**Tree Inventory, Assessment,
and
Protection Report**

**16220 Harwood Road, Los Gatos
Los Gatos, CA 95032**

Prepared for:

Town of Los Gatos

A1: Existing and Proposed Site Plan

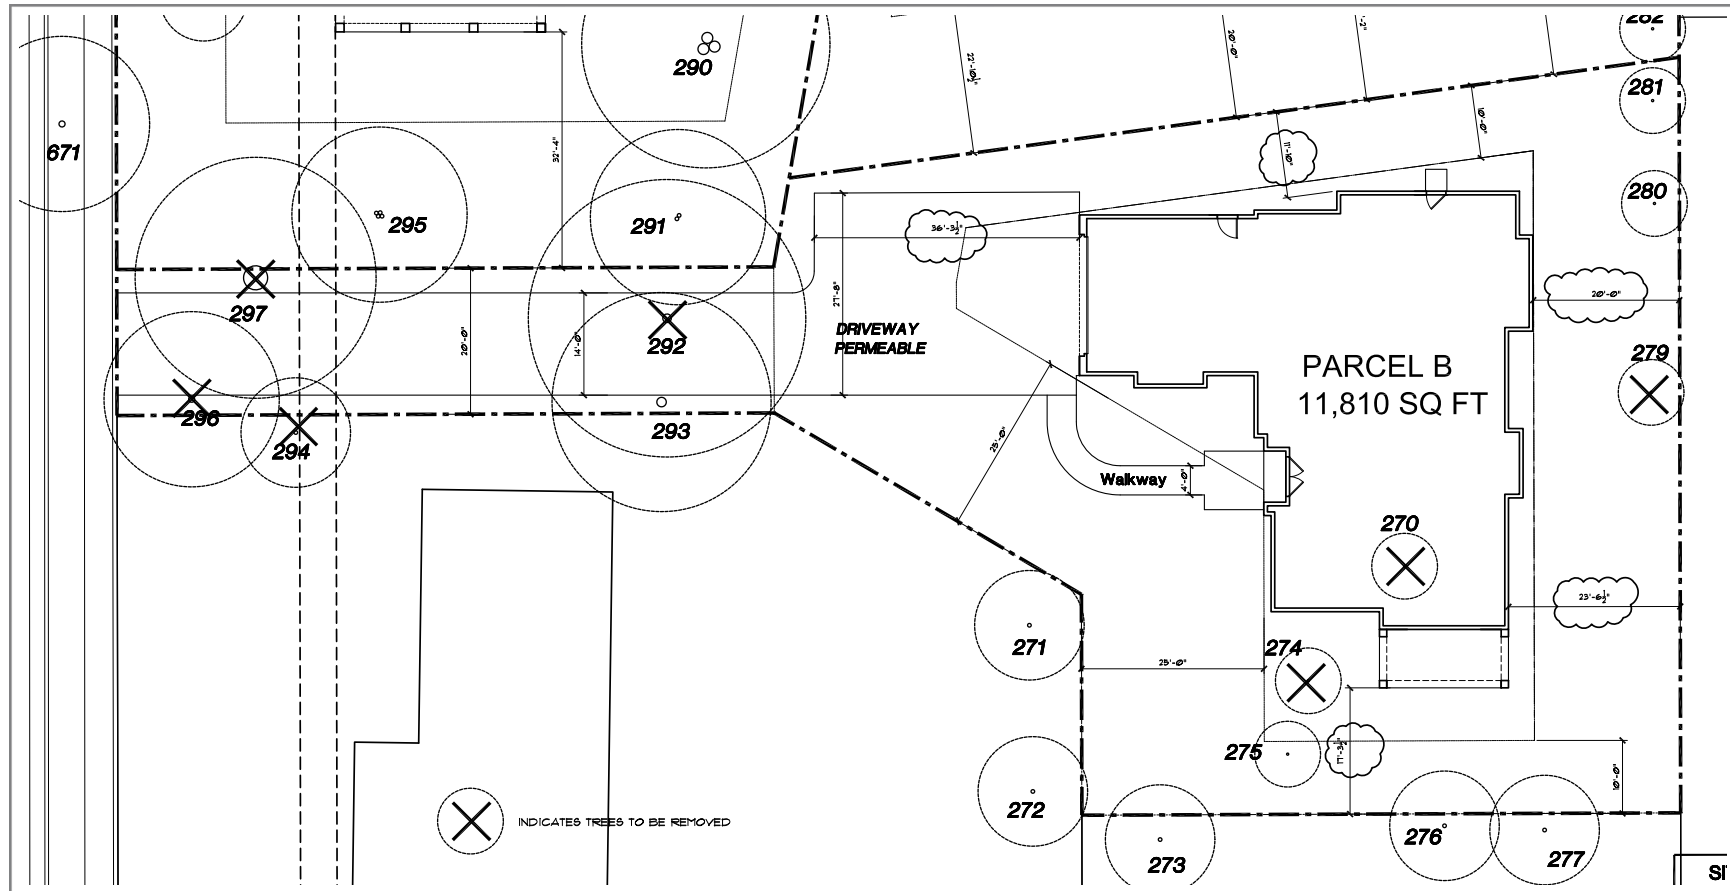
Eight trees will be highly impacted and caused to be removed, although the plans only call out seven. The eighth tree is Chinese elm #293 at the edge of the proposed driveway. Not sure how or why the others are to be removed but this one indicated as a retain. The tree will not survive the construction around it. Two additional trees could be moderately affected and include Chinese elms #291 and #295. Tree #272 is in poor condition but not expected to be affected, #295 is in poor conditions and expected to be moderately impacted, and #275 is in very poor shape and not expected to be impacted, all three of these should be considered for removal along with the eight highly impacted.

The table below indicates the recommended replacement values (Table 2). The applicant is required to replace eight protected trees according to the ordinance. Alternatively it may be possible to create an approved landscape plan or provide an in-lieu payment. The landscape plan does not adequately provide the required replacements and indicates two pittosporum and five myrtles 5 and 10 gallon container size, there is no tabular format indicating the quantity and species, and the species chosen on the plan sheet are all very small growing.

1. Place tree protection fence around the perimeter of the site at the appropriate radius as indicated in Appendix B.
2. Consider removing #293 or reconfiguring the driveway.

3. Provide a replacement landscape plan to account for the eight protected trees.
4. Install temporary irrigation or soaker hoses in all tree protection zones and provide supplemental watering during construction within all TPZ areas. Infrequent deeper watering is preferred.

A2: Grading and Drainage Plan

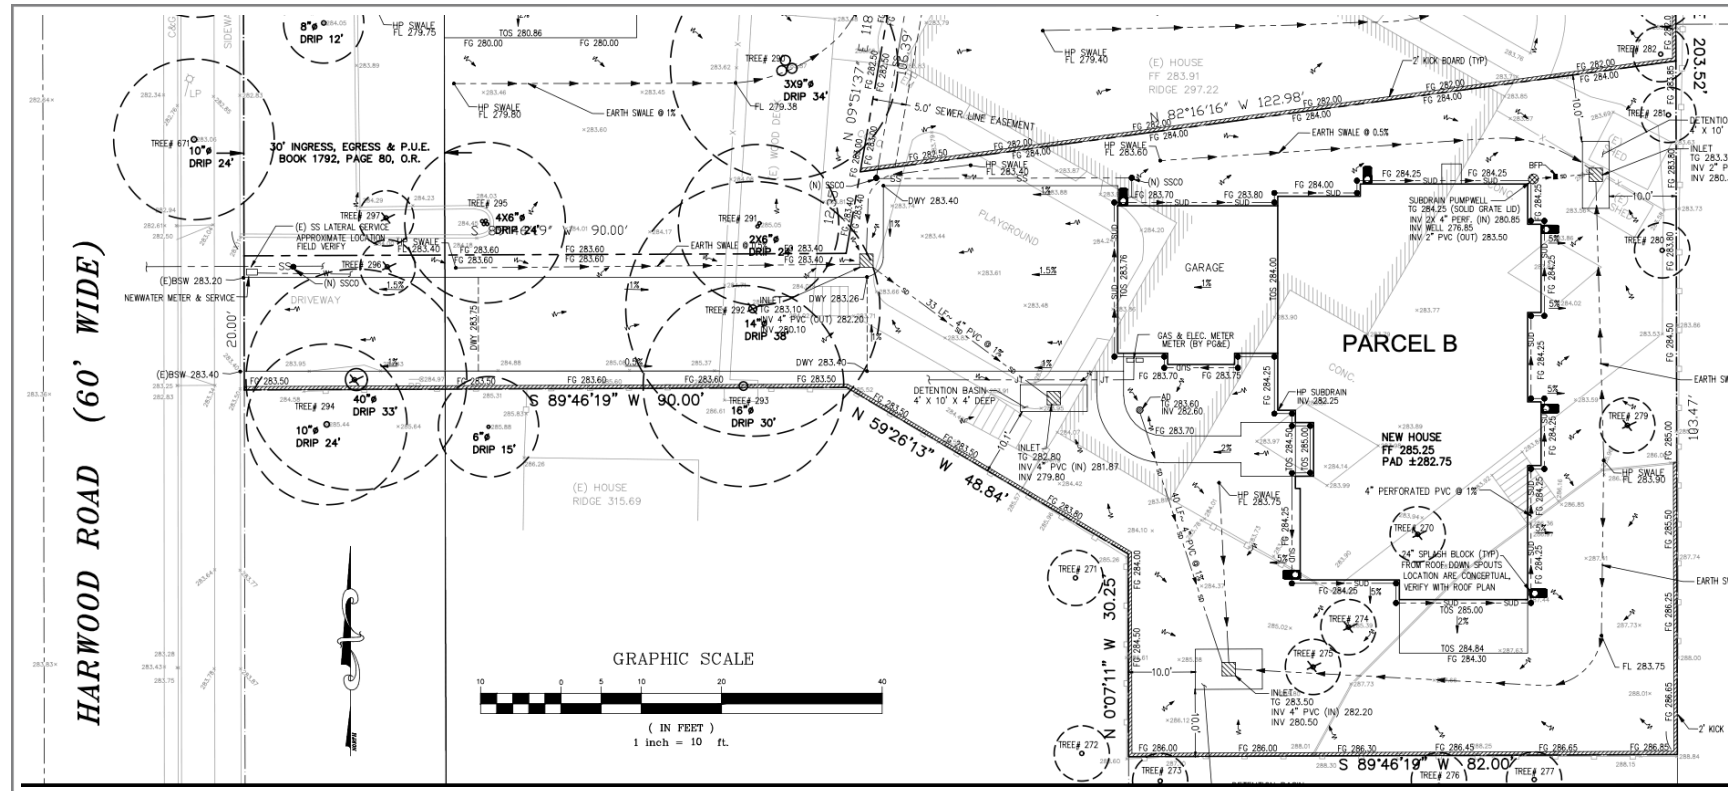
7. Place all the tree protection fence locations and guidelines on the plans including the grading, drainage, and utility plans. Create a separate plan sheet that includes all three protection measures labeled “T-1 Tree Protection Plan.”
